AREA TOPOGRAPHICAL SURVEY		
PROPOSED CONVOCATION CENTER ARKANSAS STATE UNIVERSITY ONESBORO, ARK.		
PREPARED BY: HAYWOOD KENWARD & ASSOCIATES, INC. CIVIL Engineering & Surveying Jonesboro, Ark.	DATE: 10-83	SCALE: 1"=100'
DRAWN BY: J.K.		1:1

A.S.U. CONVOCATION CENTER

SITE PLAN

7/25/84

FLOOR PLAN QUADRANT "A" FIRST LEVEL

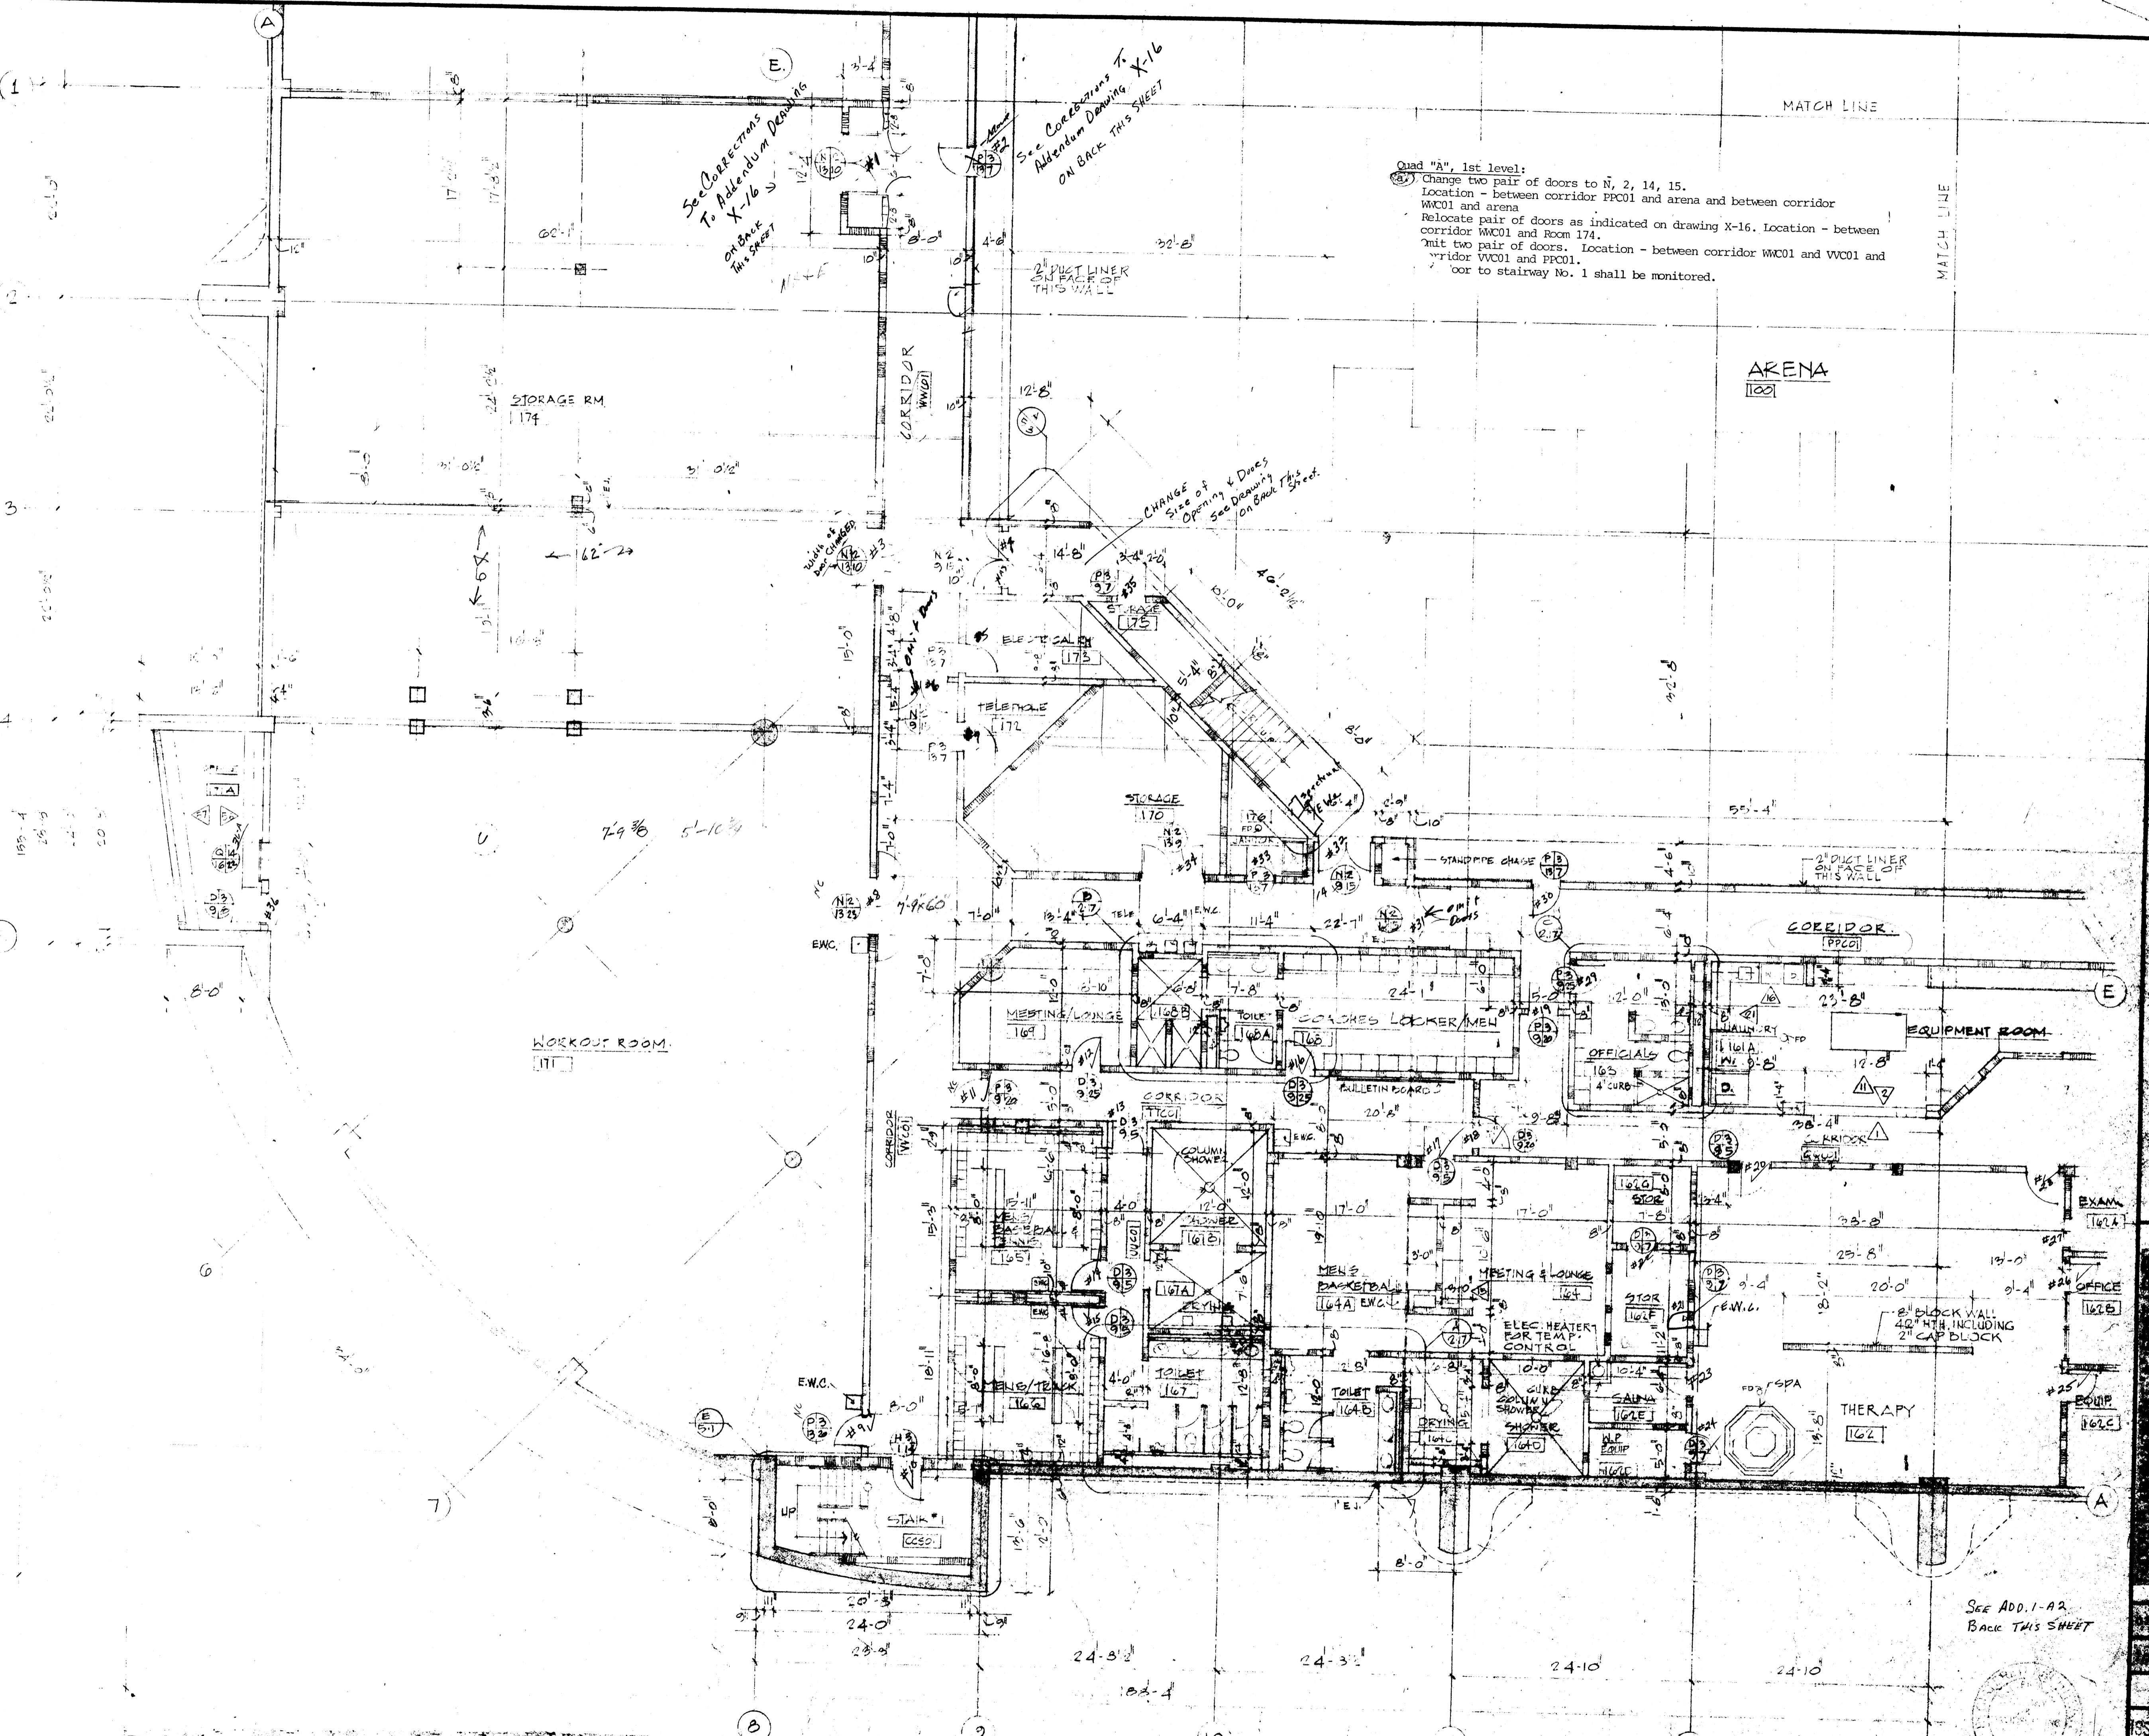
Quad "A", 1st level:
 Change two pair of doors to N, 2, 14, 15.
 Location - between corridor PPC01 and arena and between corridor WWC01 and arena
 Relocate pair of doors as indicated on drawing X-16. Location - between corridor WWC01 and Room 174.
 Add two pair of doors. Location - between corridor WWC01 and WWC01 and corridor WWC01 and PPC01.
 Door to stairway No. 1 shall be monitored.

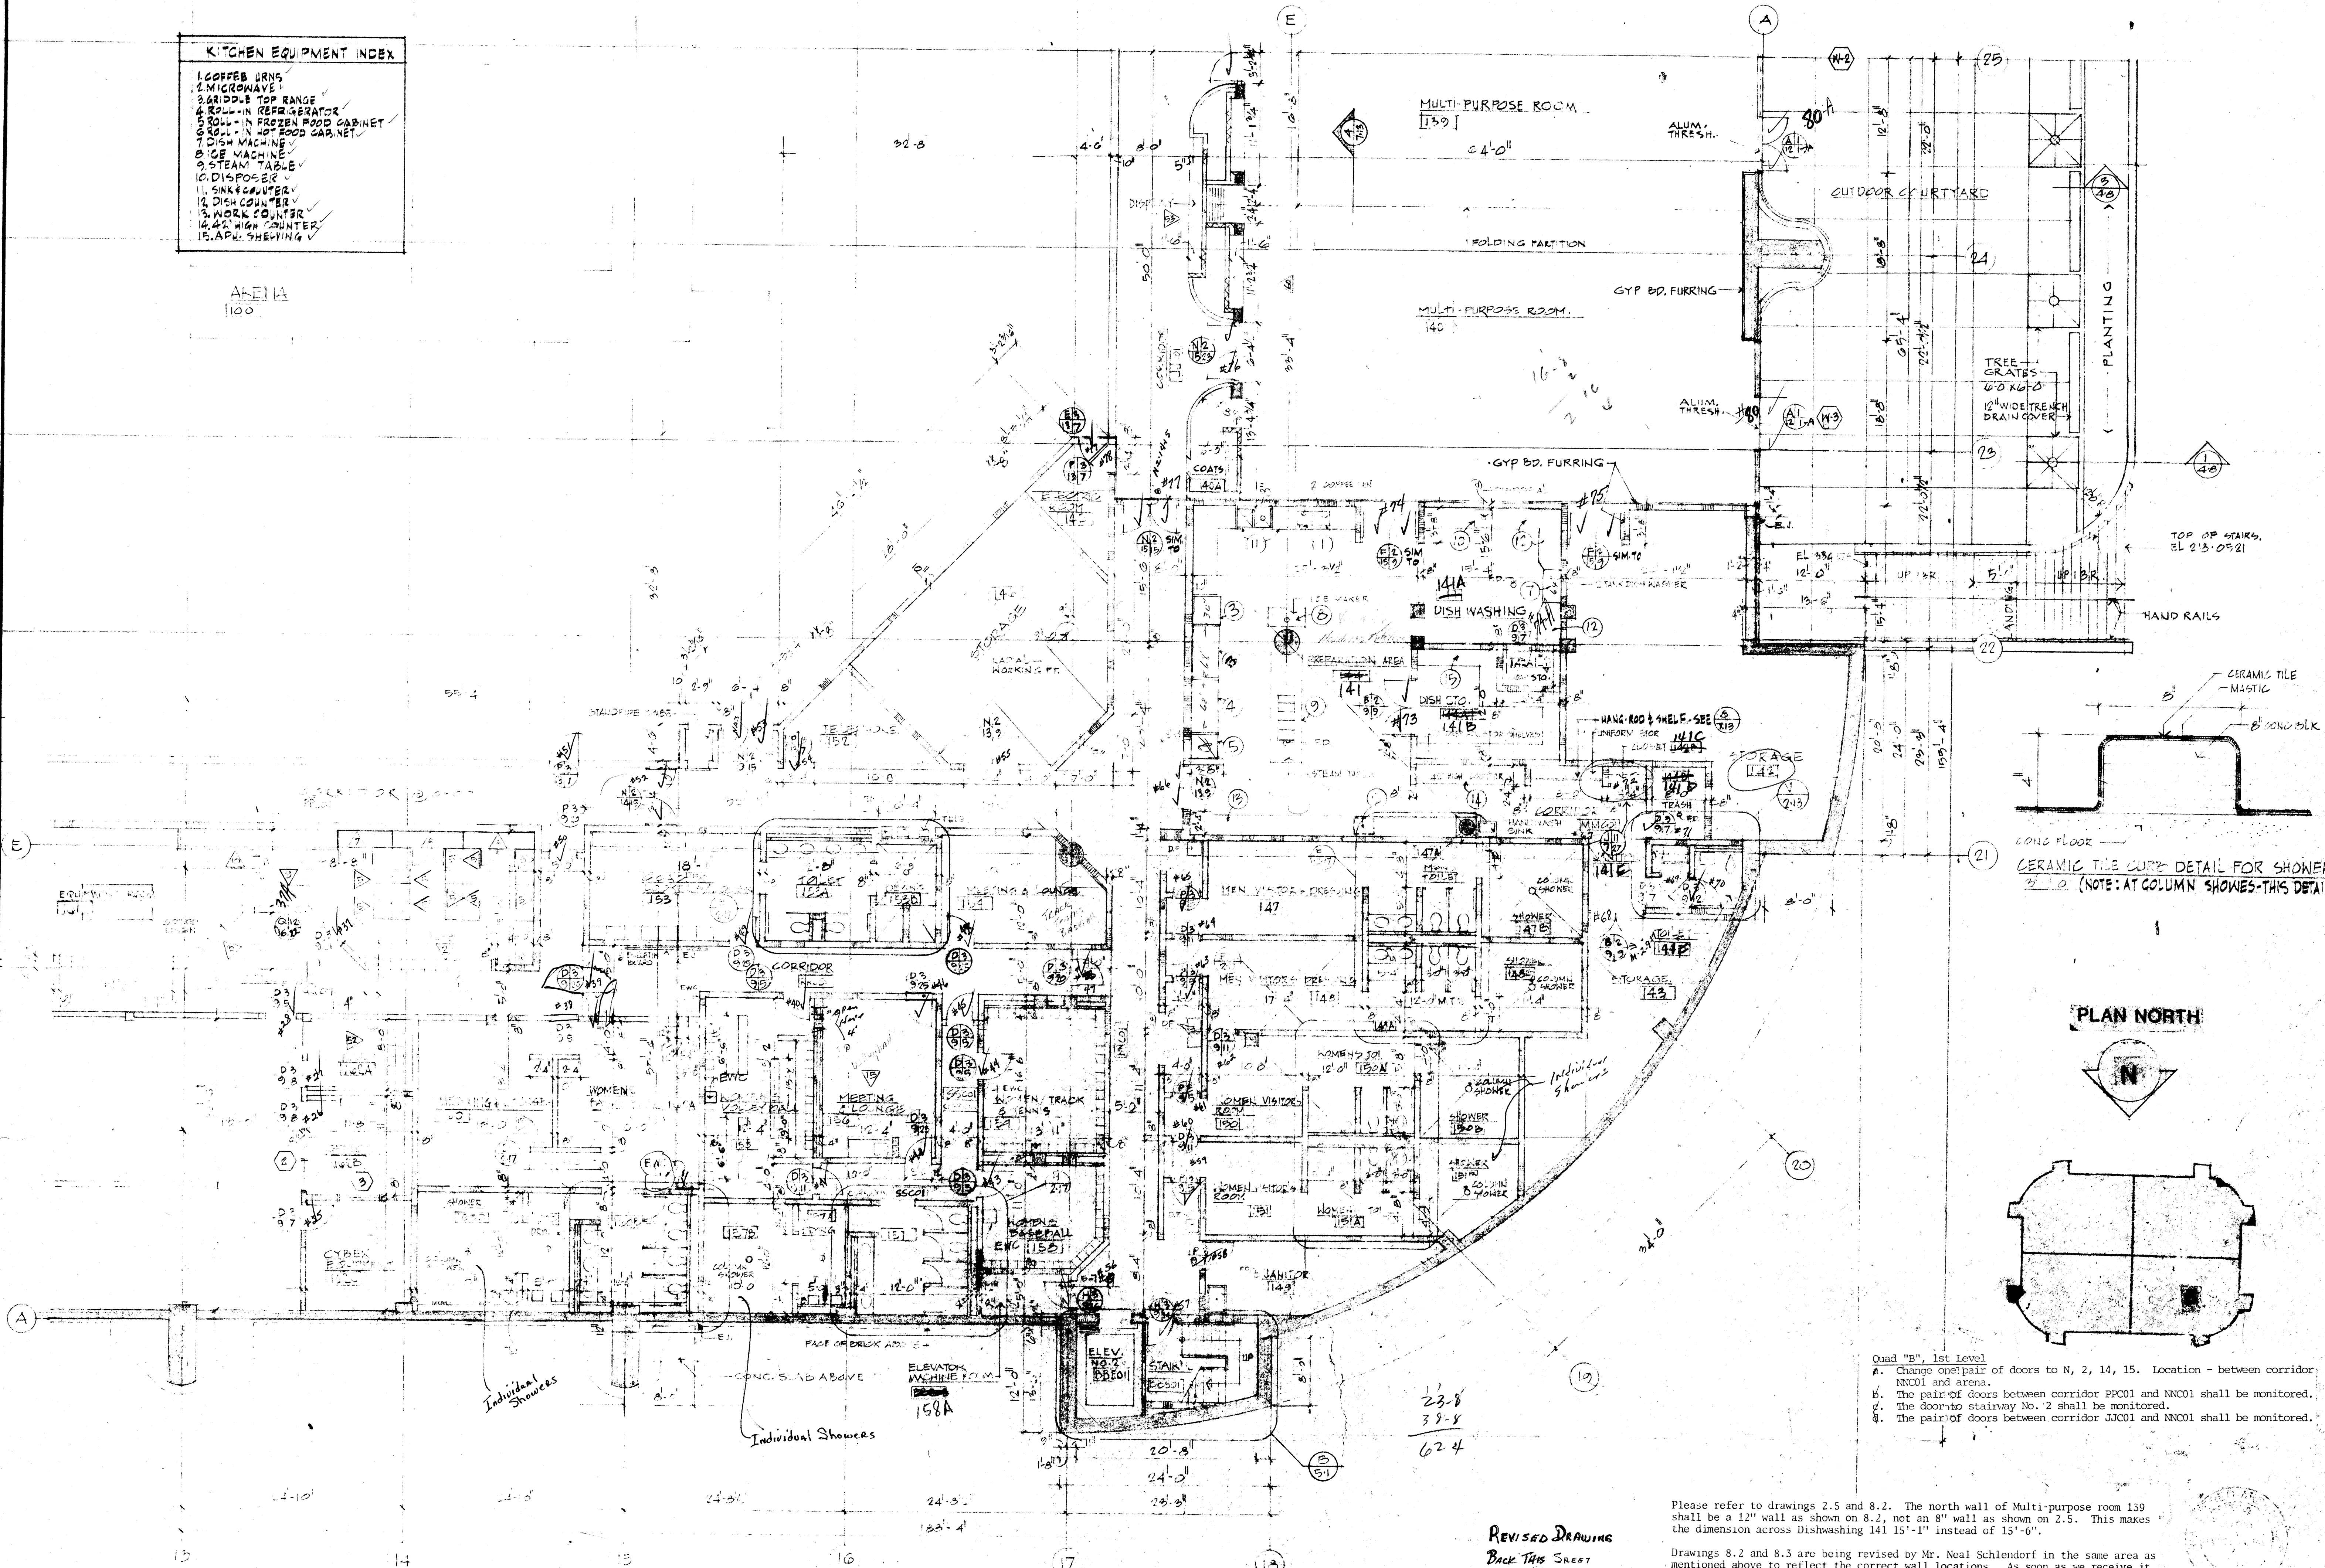
- Quad "B", 1st Level
- a. Change one pair of doors to N, 2, 14, 15. Location - between corridor NNC01 and arena.
 - b. The pair of doors between corridor PPC01 and NNC01 shall be monitored.
 - c. The door to stairway No. 2 shall be monitored.
 - d. The pair of doors between corridor JJC01 and NNC01 shall be monitored.
